Staff Report to the Ogden Valley Planning Commission

Agenda Item: CUP: 2023-01 Request for approval of a conditional use permit for a public utility substation

that will house a well pumping facility for Wolf Creek Water and Sewer Improvement

Application Type: Administrative File Number: CUP 2023-01

A. Building elevations and Site Plan

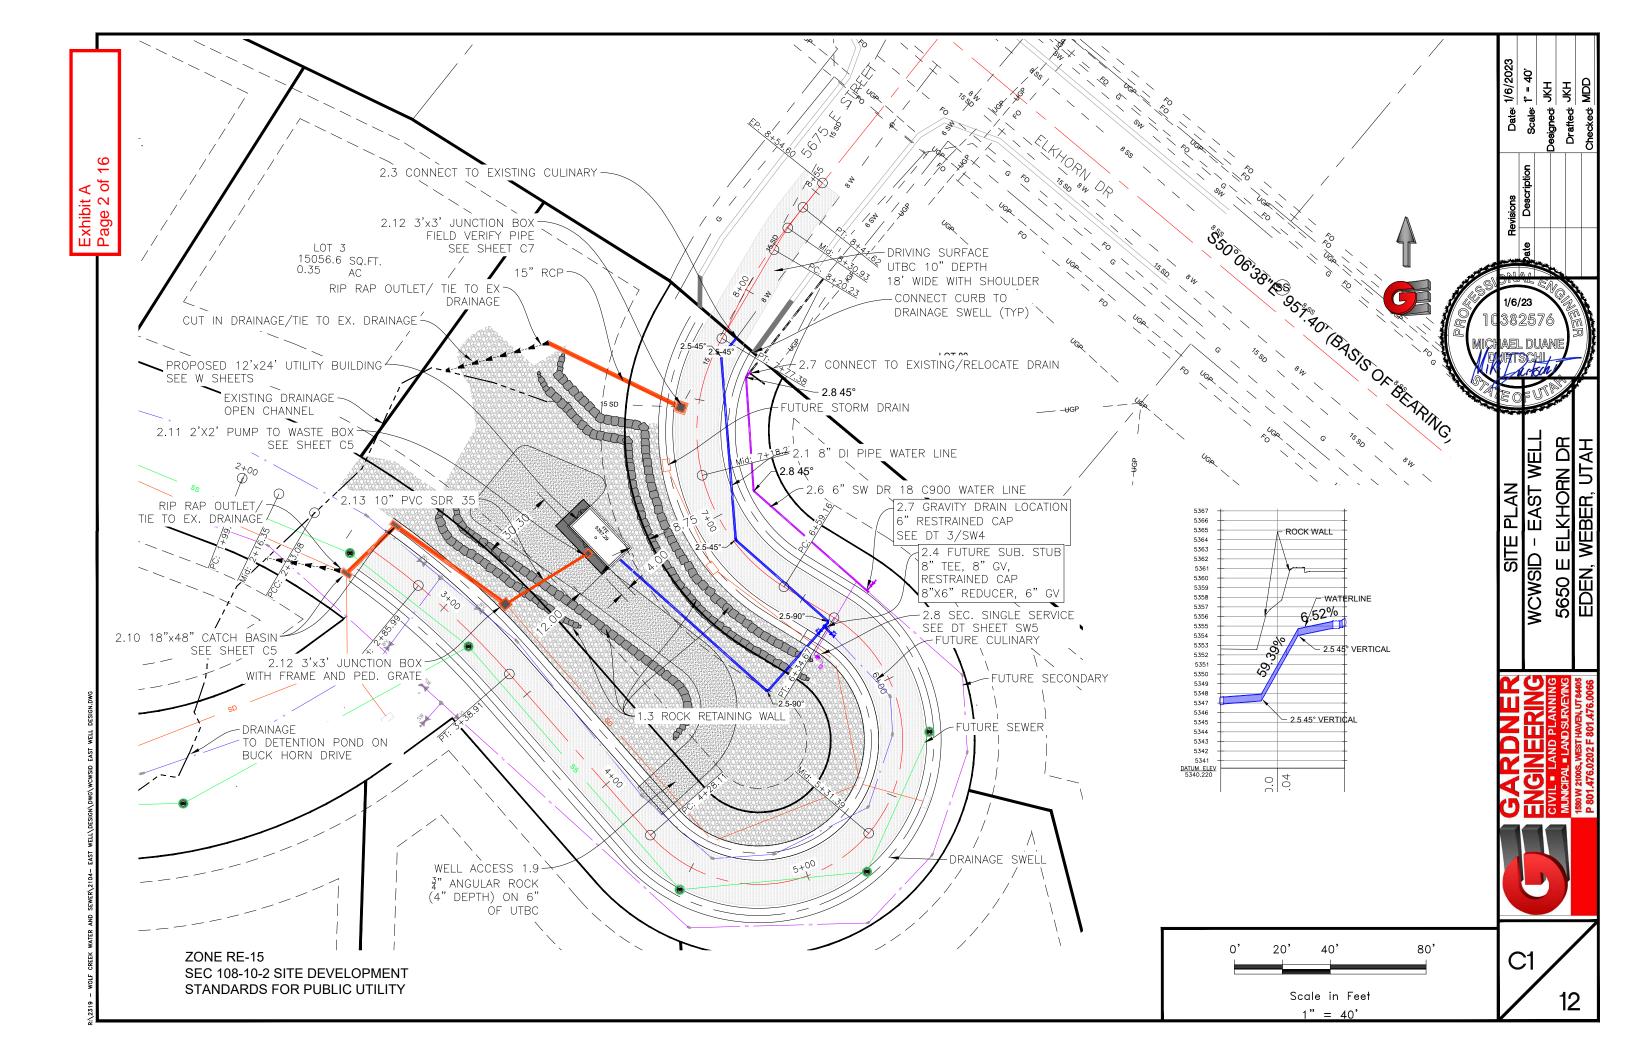
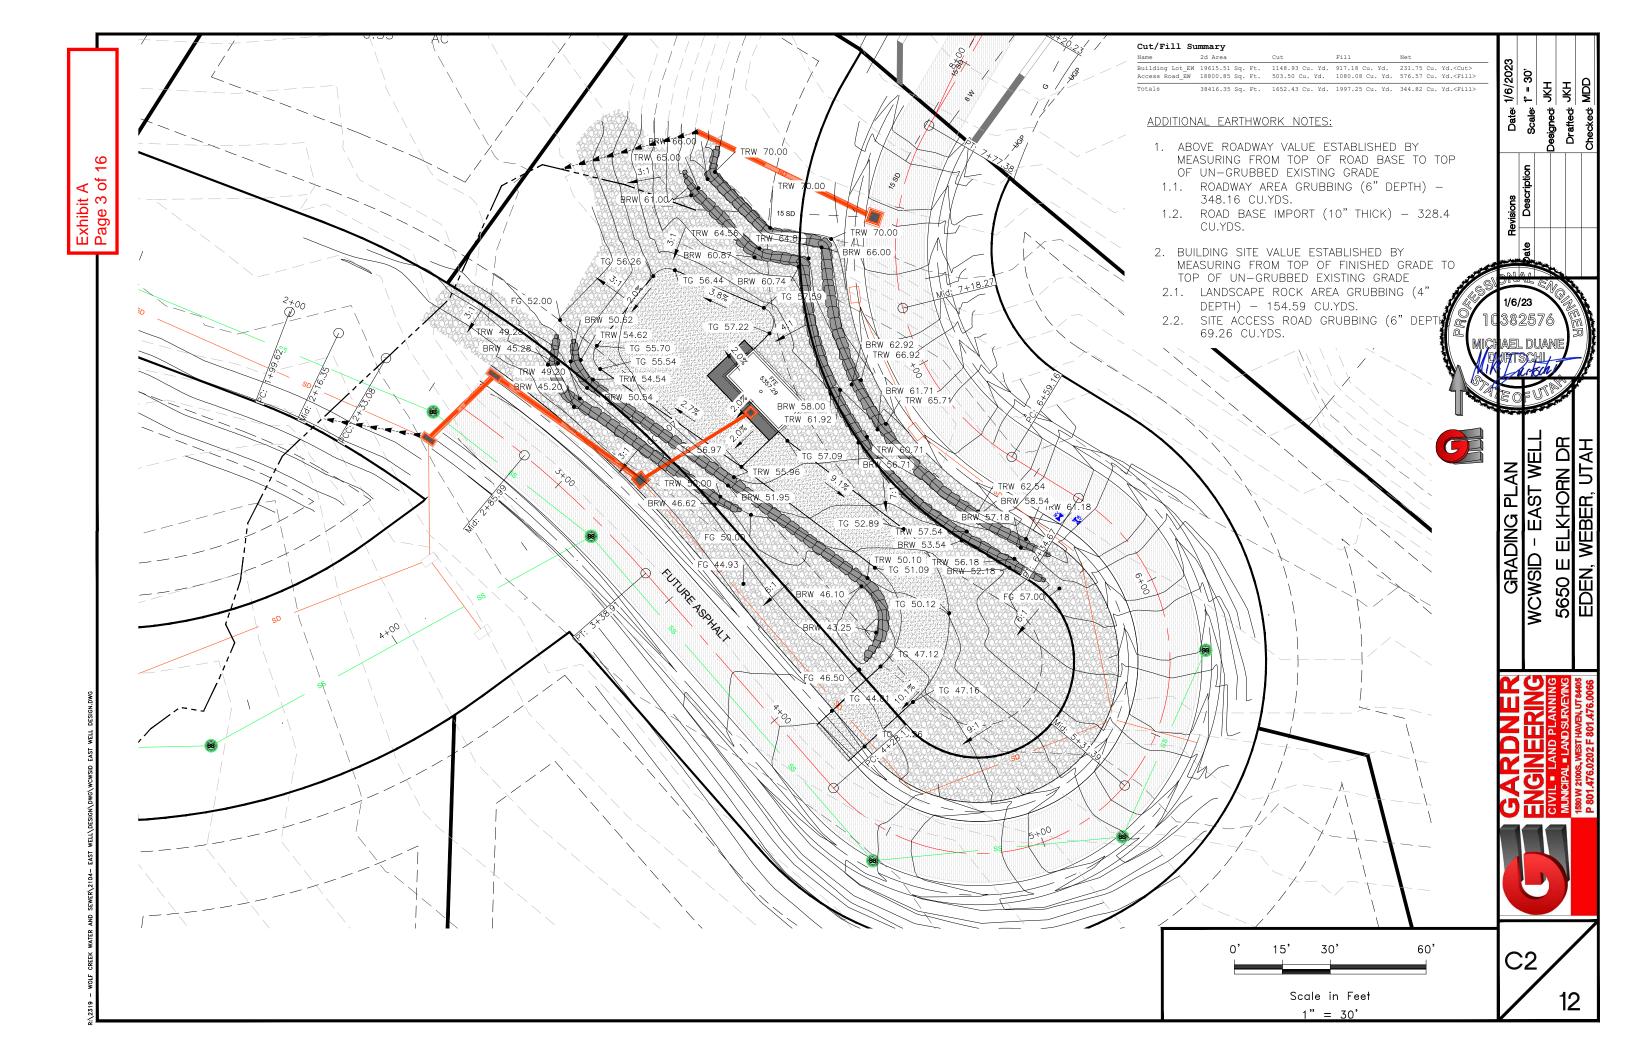
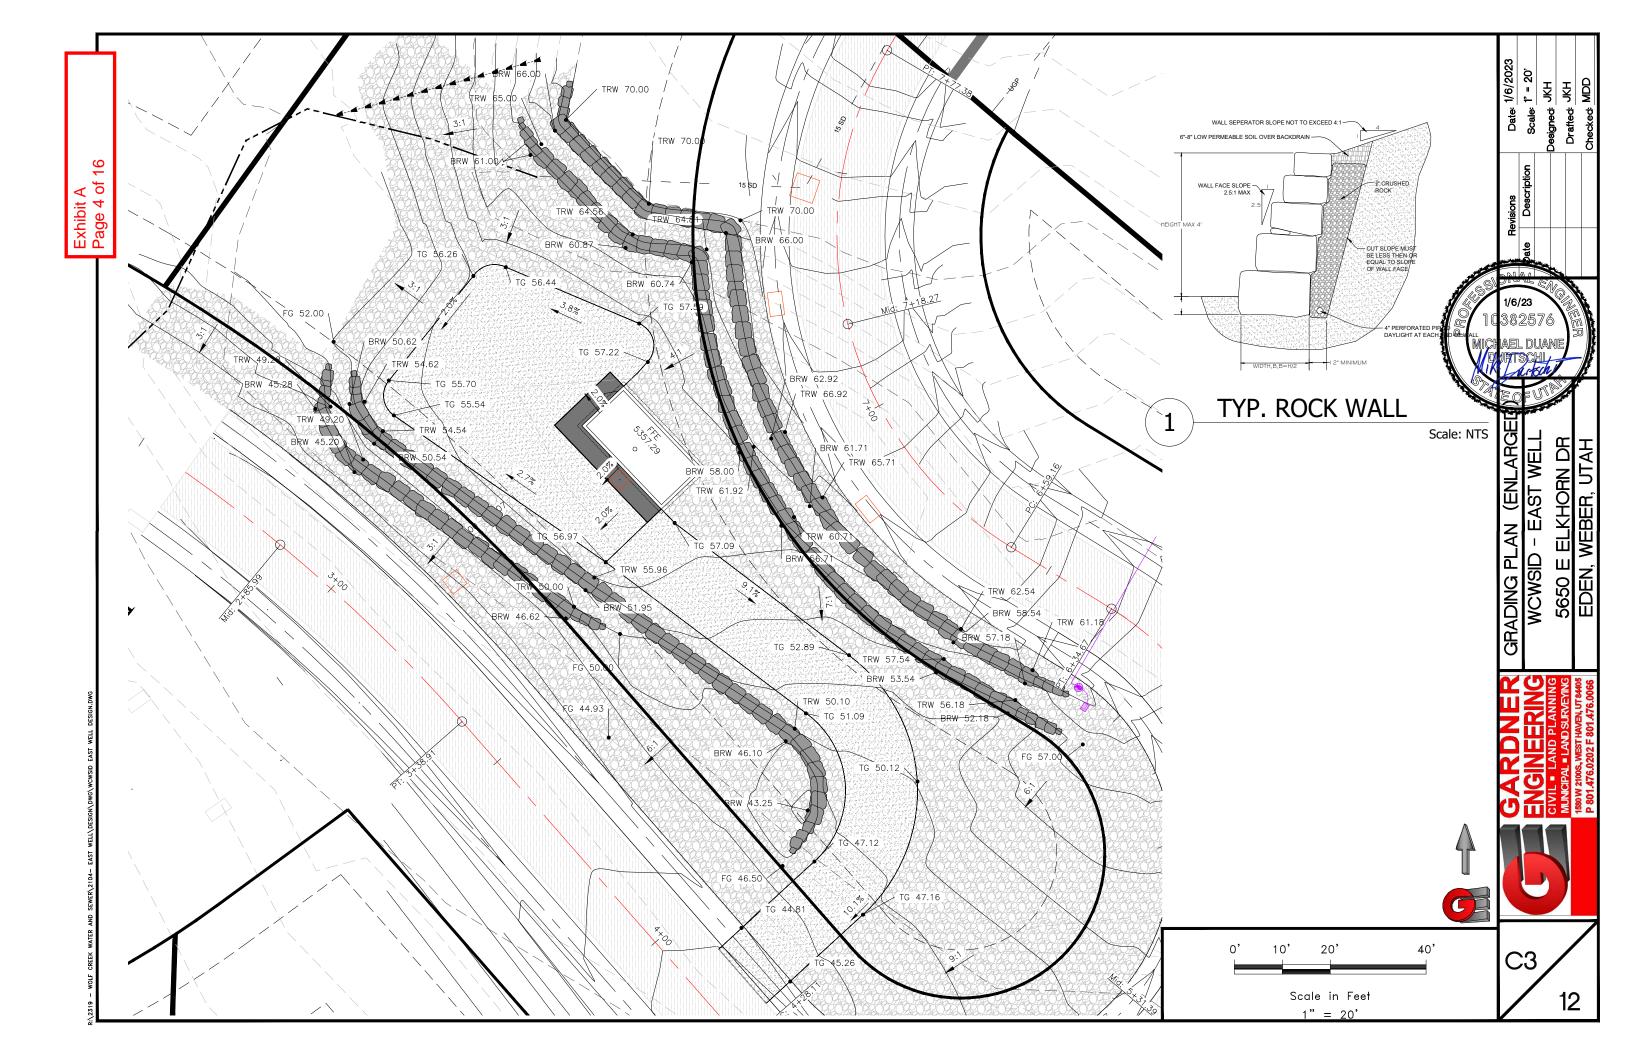
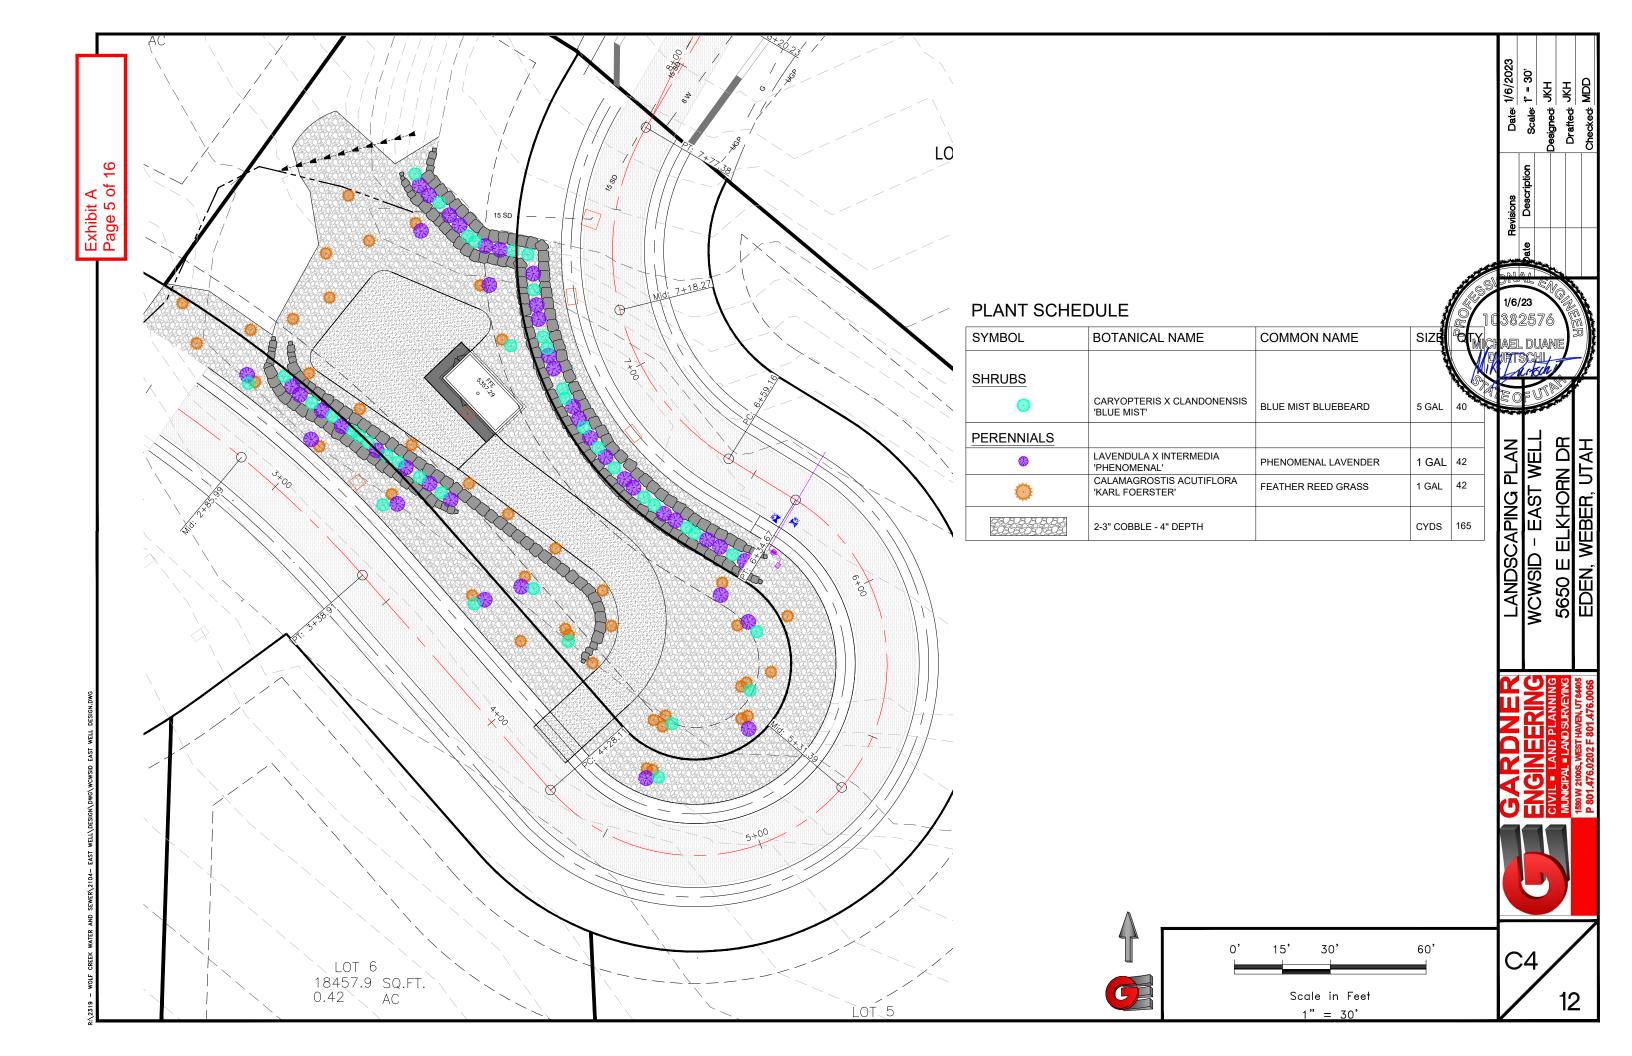
The proposed site plan indicates that the well house and tank will be 30 feet from the front lot line, 8 feet from the rear lot line, and 20 feet from the side lot lines. This proposal meets the zoning setbacks except for the rear setback requirement of 30 feet, however, Sec 108-10-2, site development standards allow a rear setback of five feet minimum.

Considerations relating to traffic safety and traffic congestion. The proposal includes a site plan that identifies an access road to the pump house off of the future public street. Neither traffic safety hazards nor traffic congestion are anticipated given the minimal site visitations to the substations.

Considerations relating to landscaping. The owner has provided a landscaping plan that includes drought tolerant perennials and shrubs, included as part of exhibit A. The proposed landscaping plan meets the requirements outlined in the Architectural, Landscape, and Screening Design Standards (108-2).

ELEVATION (2)
WCWSID - EAST WELL
5665 EAST ELK HORN DRI'
EDEN, WEBER, UTAH

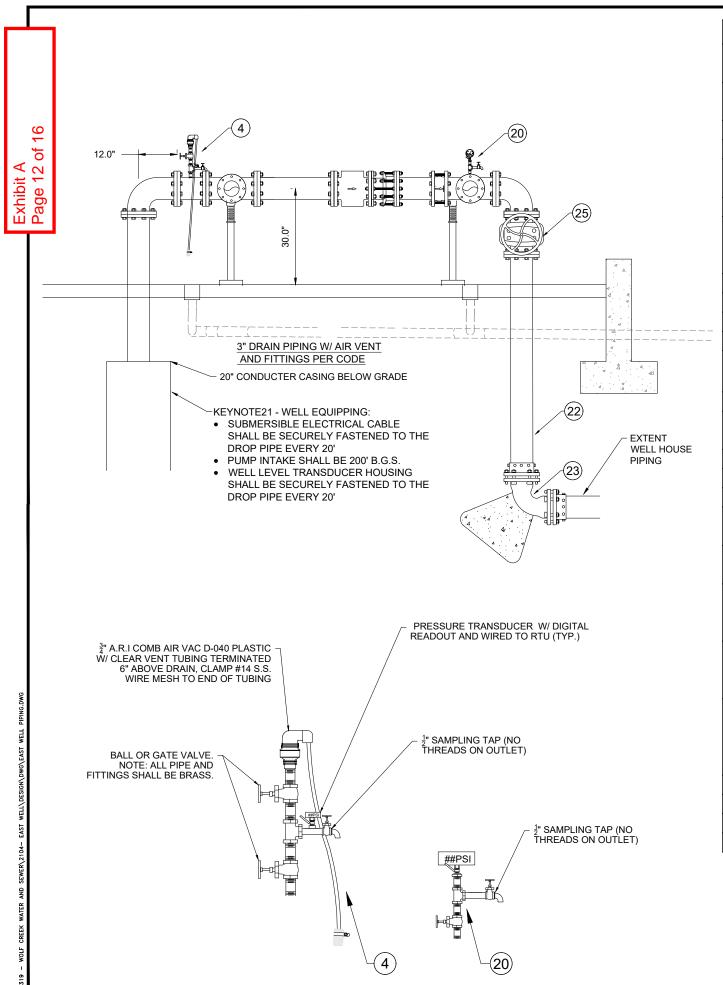
Considerations relating to buildings and site layout. The applicant has submitted elevations of the proposed pump house (Exhibit A) that indicate the outside of the building will consist of hardieplank lap siding, split face CMU, and steel roofing, which complies with the aesthetic requirements outlined in LUC 108-2.

1. Any outdoor lighting must meet the requirements of the Ogden Valley Outdoor Lighting Ordinance (108-16).
